Service Bulletin

Bulletin No.: 23-NA-168

Subject: Velocity IME Upgrade Information

Brand:	Model:	Model Year:		VIN:		Engine:	Transmission:
		from	to	from	to		
Cadillac	LYRIQ	2024	2024	—	—	—	—

6425546

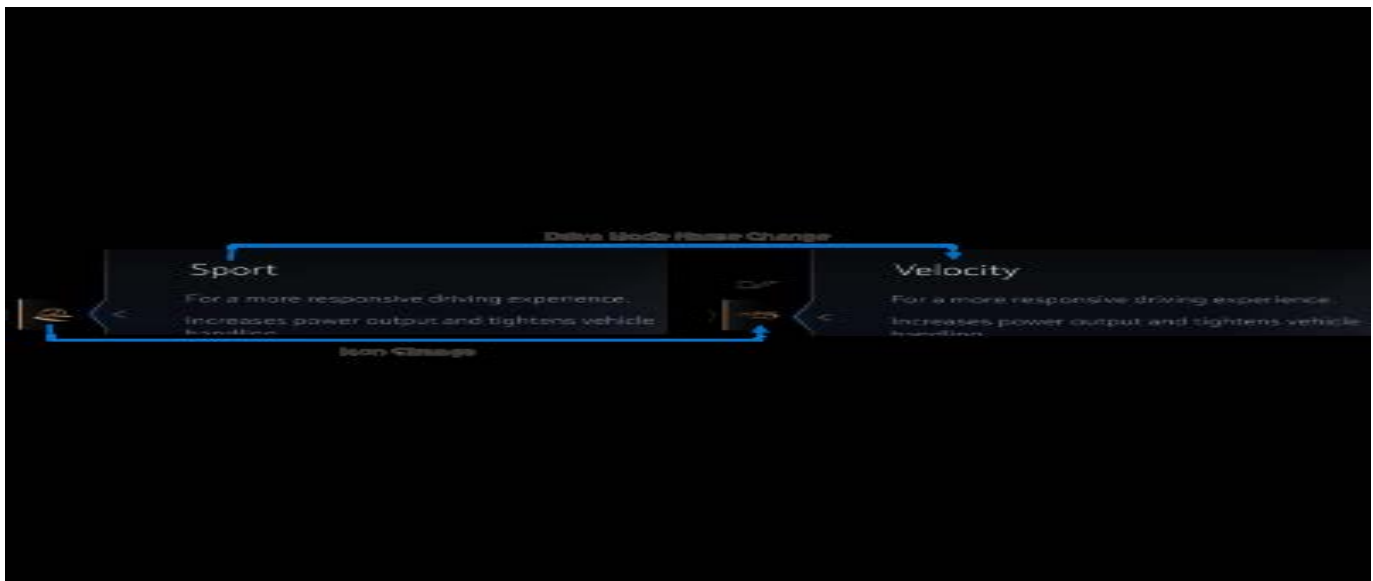
After installation, there will be an option in the Driver Mode App on the center display.

Sport mode will be replaced by the Velocity Icon.
